ADDENDUM NO. 2

TRACK & FIELD IMPROVEMENTS - INC 1

Adolfo Camarillo High School

November 4, 2019

ELECTRICAL AS-BUILT PLANS FOR REFERENCE ONLY

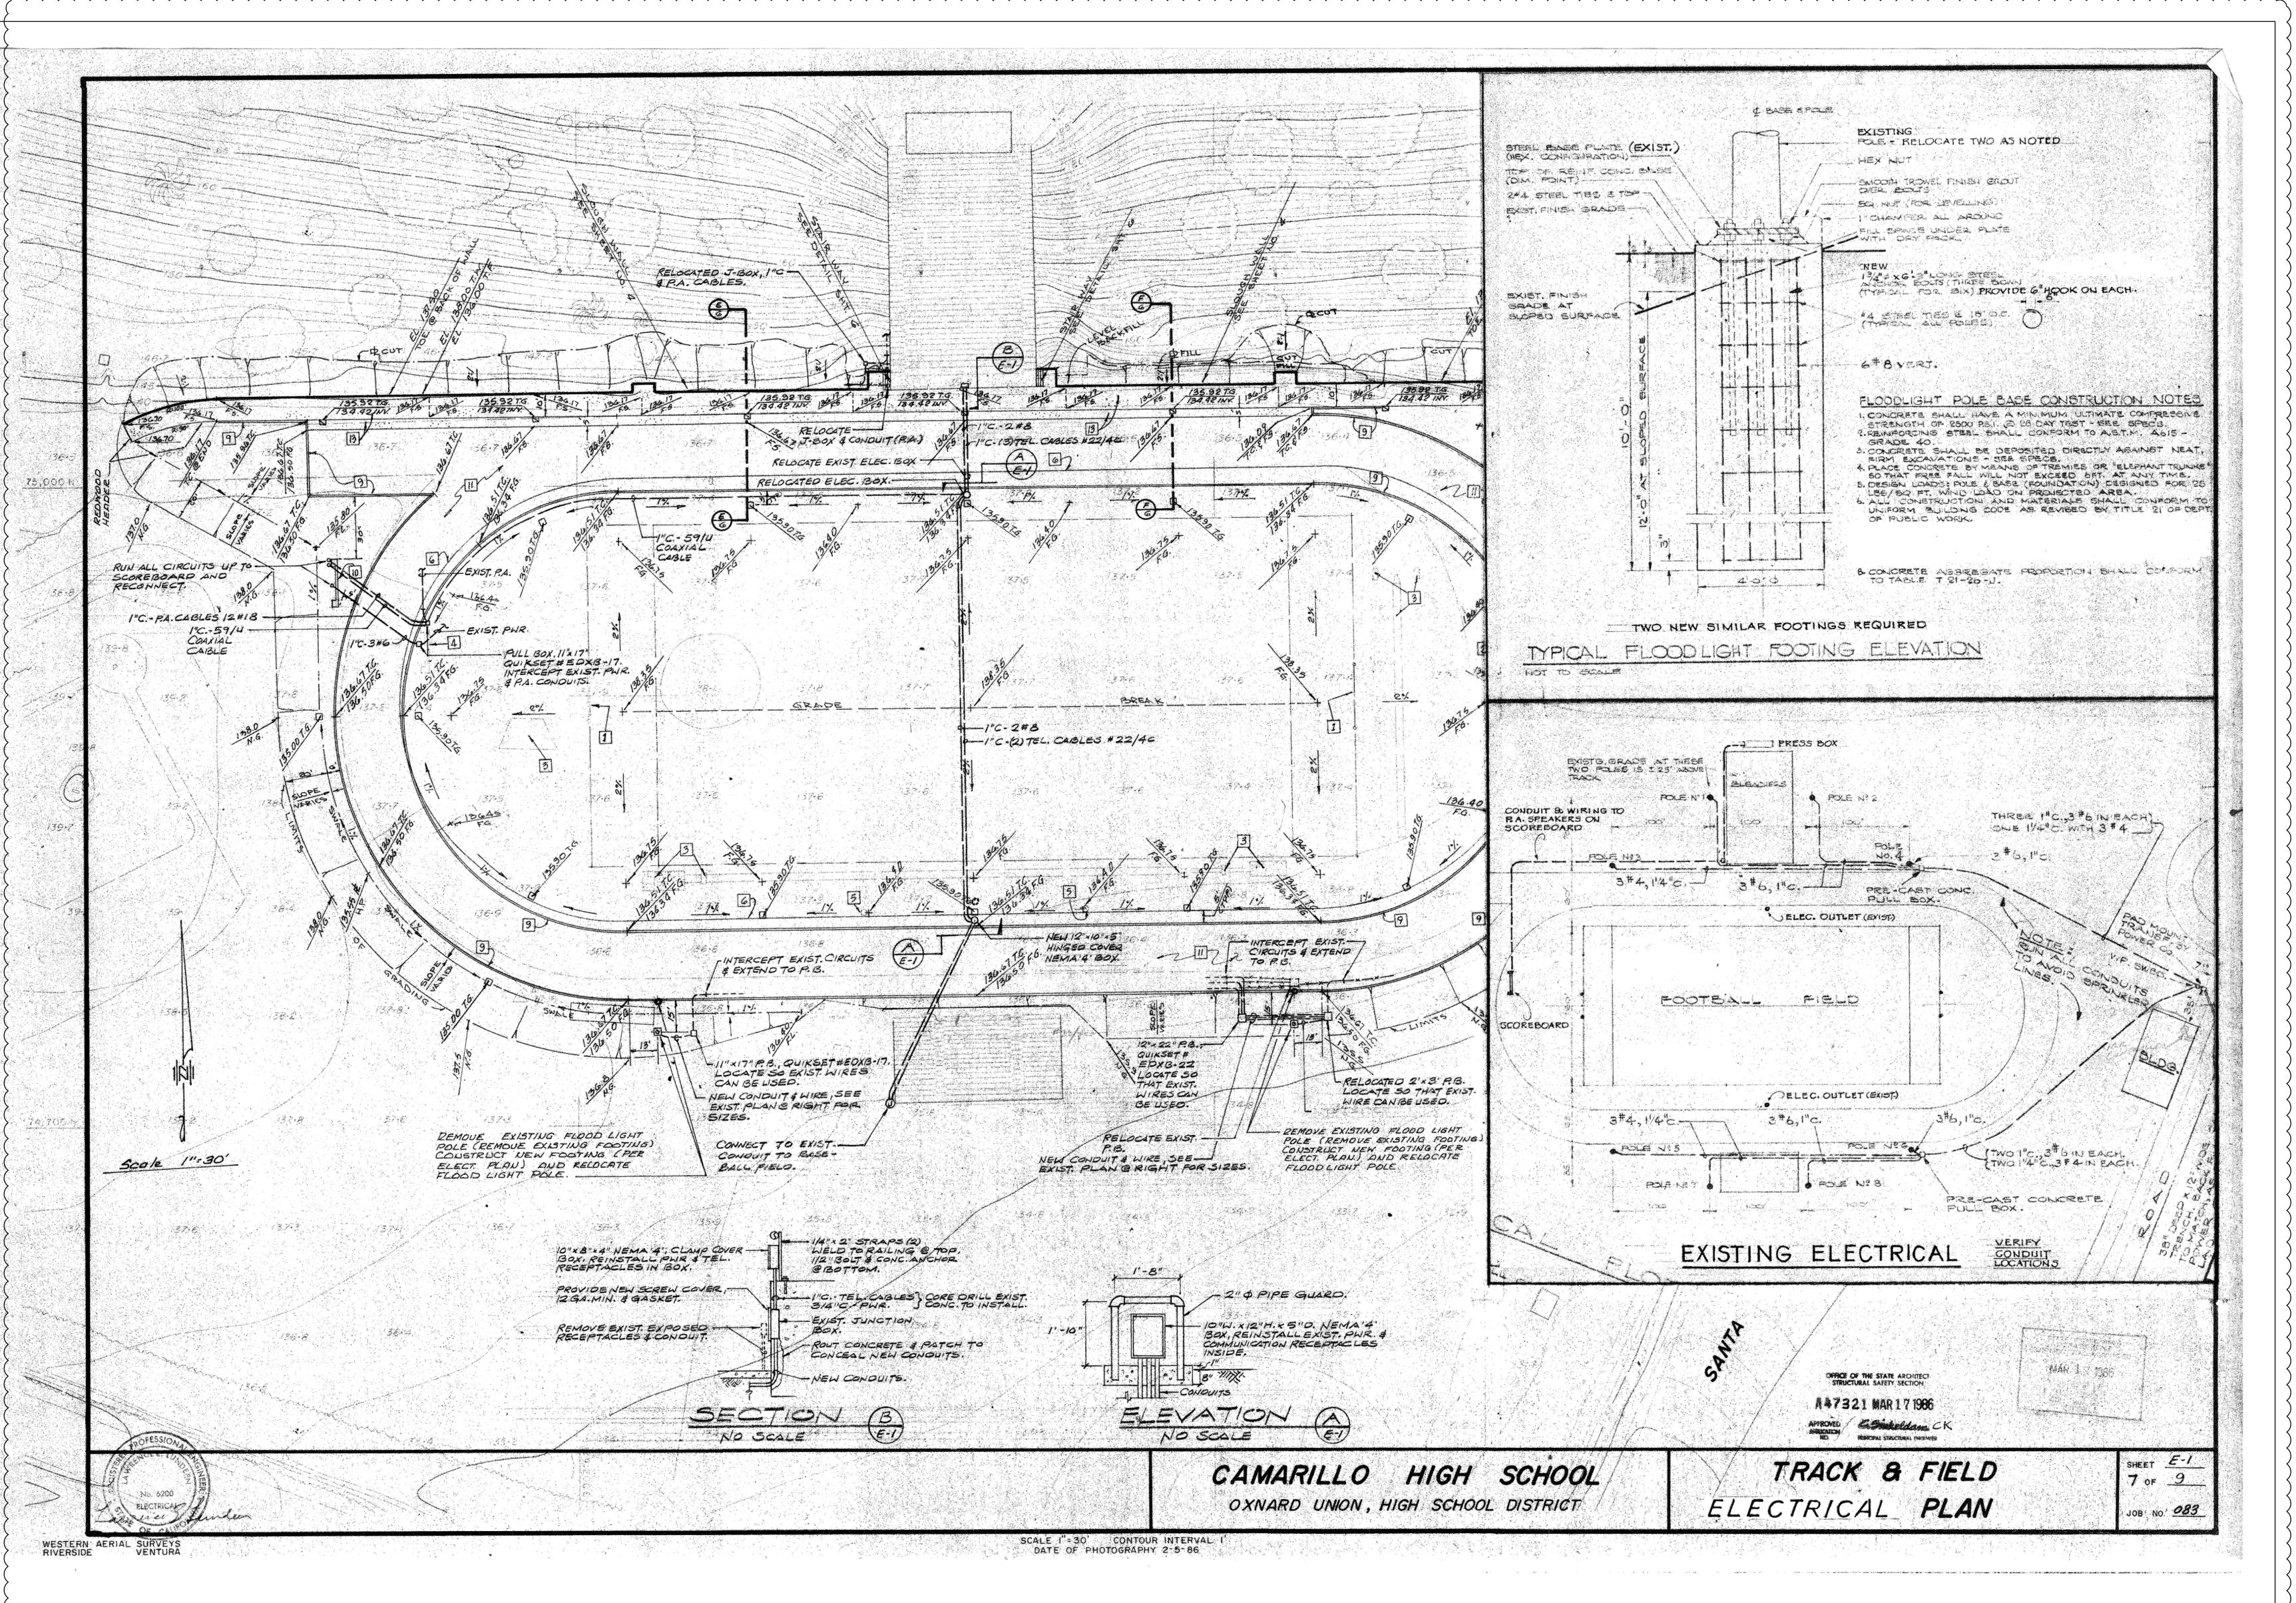
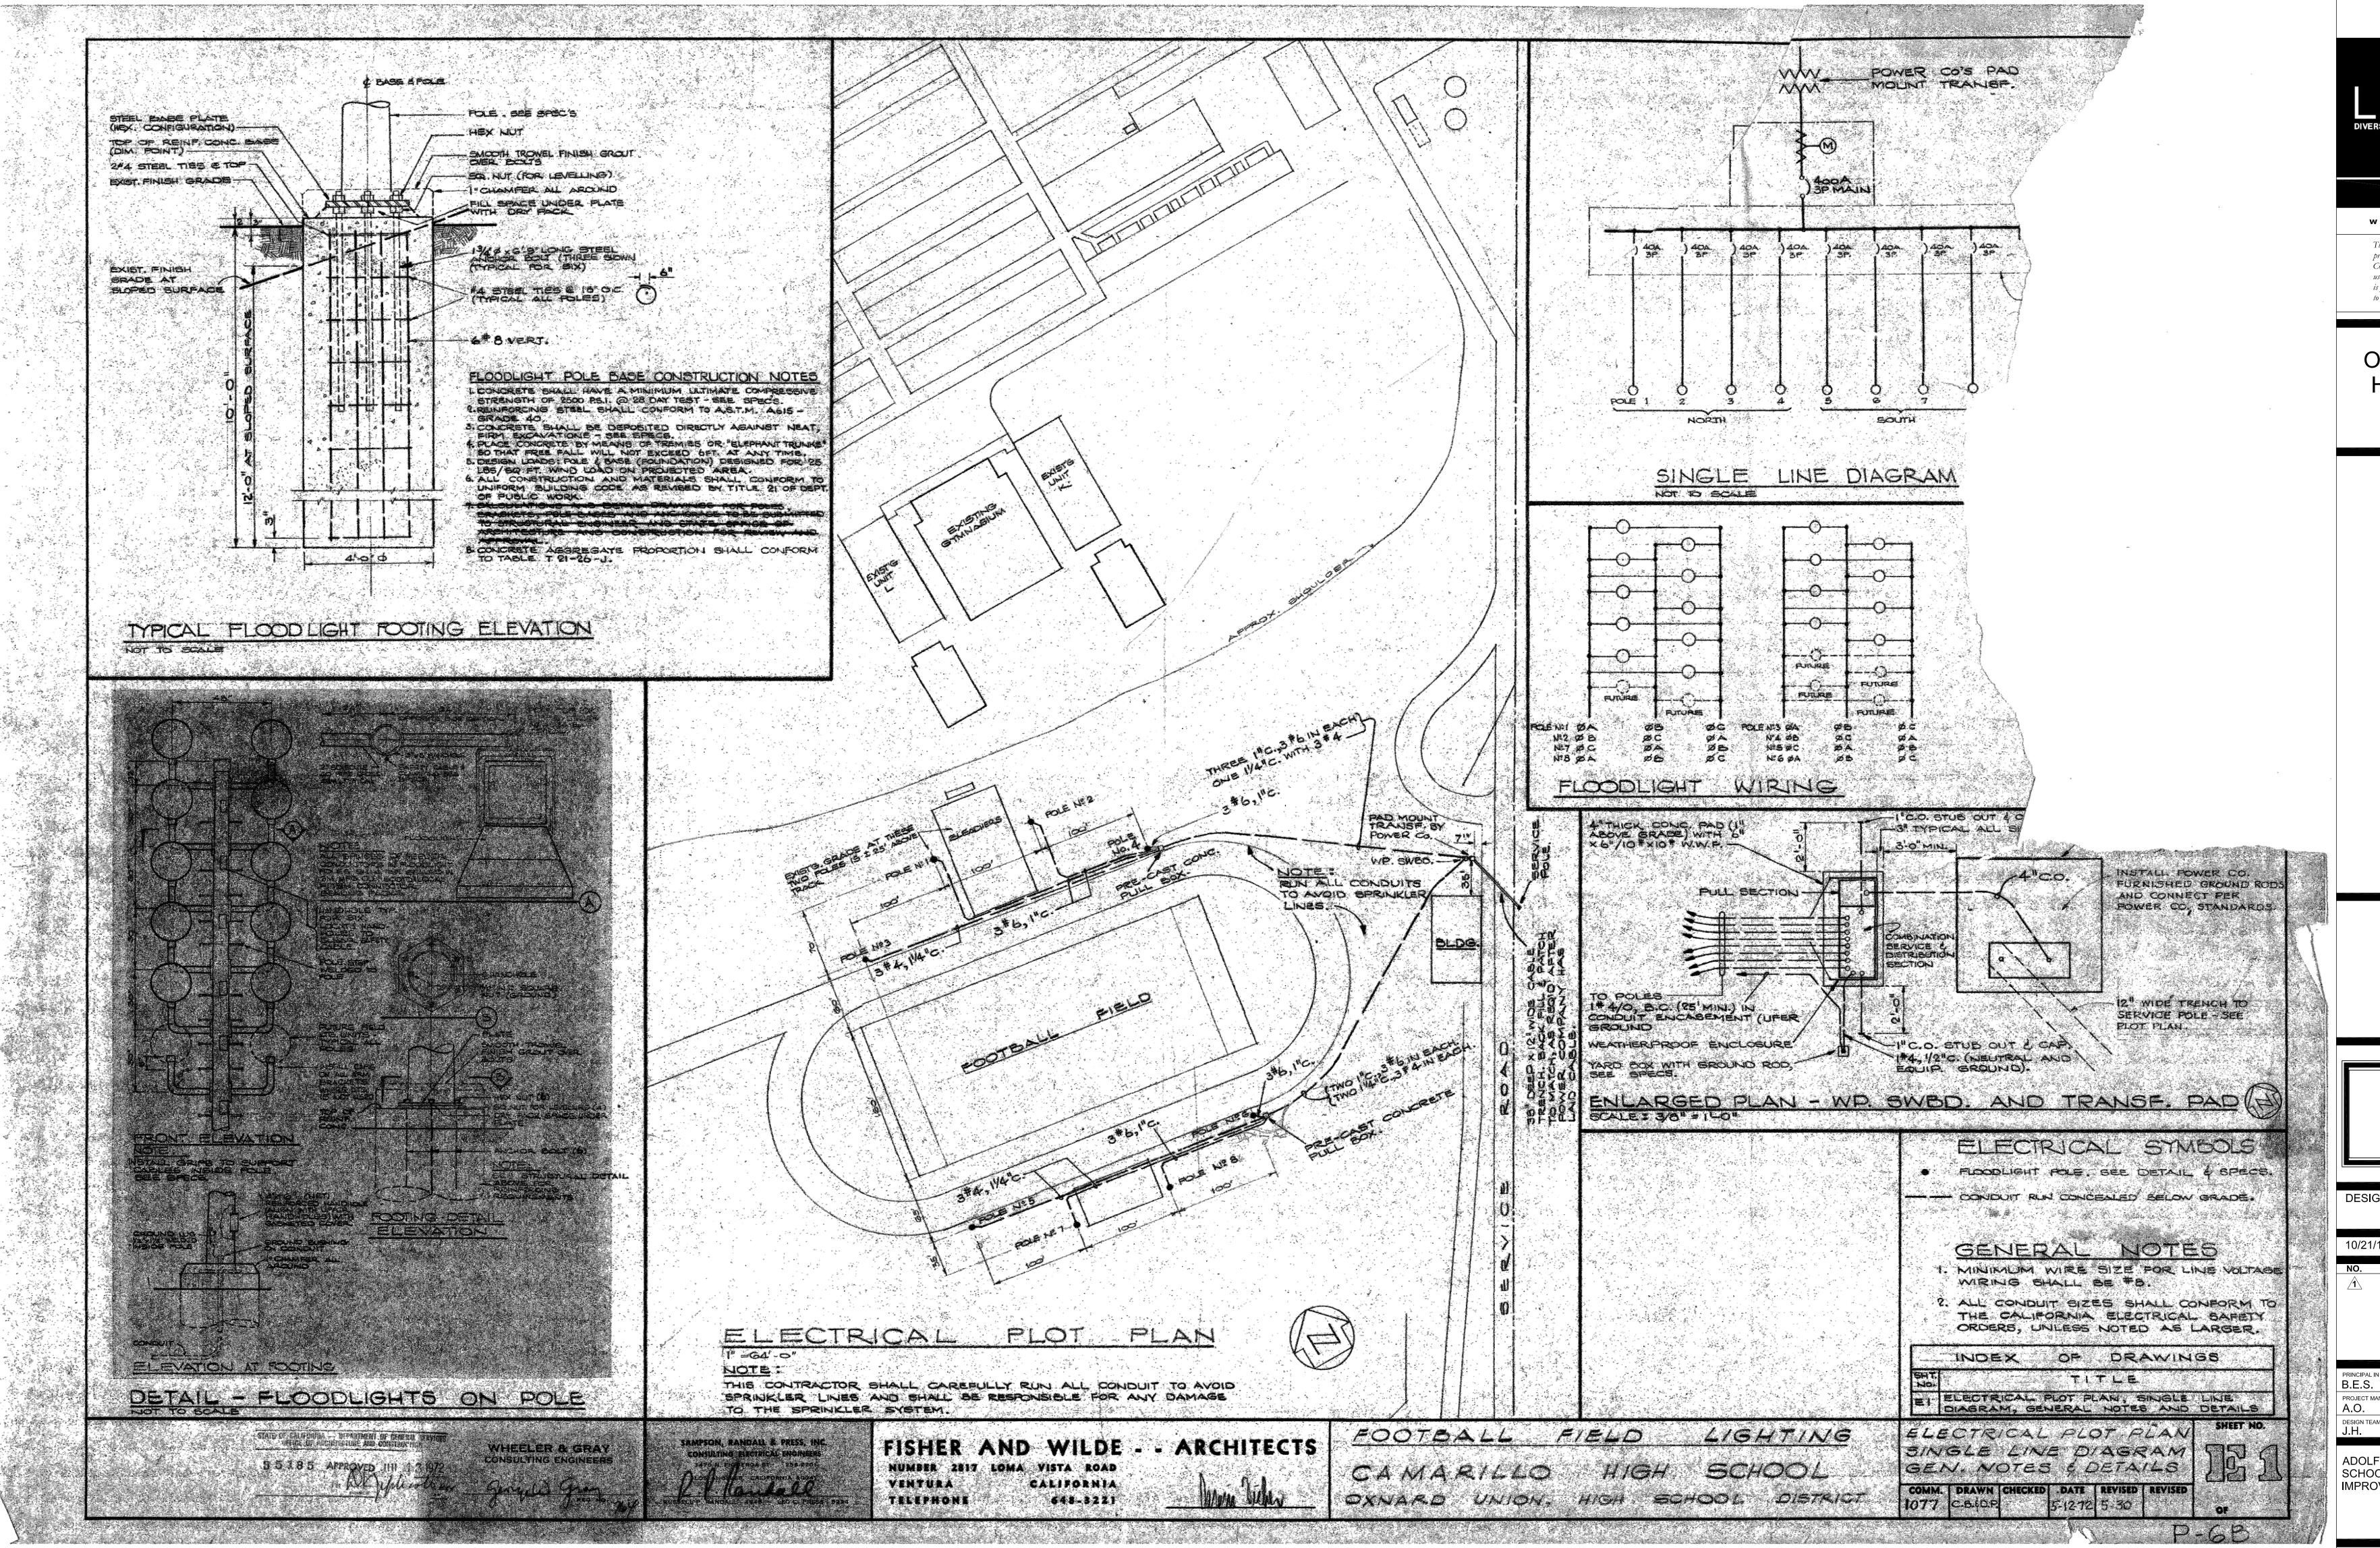
- **3.3.2.** Narrative clarifications to Electrical Drawings are issued as follows:
 - **3.3.2.1.** Drawing E-200 Clarify as follows:
 - **3.3.2.1.1.** Existing panel locations at existing switchboard are shown on E-100 (AD2-E2) and referenced on 'as-built plans' AD2-E4 & AD2-E5.

- **3.3.2.1.4.** Junction boxes to be concrete type. Contractor shall field verify for existing junction boxes to be replaced with the same size, as per 'as-built plans' AD2-E4 & AD2-E5.
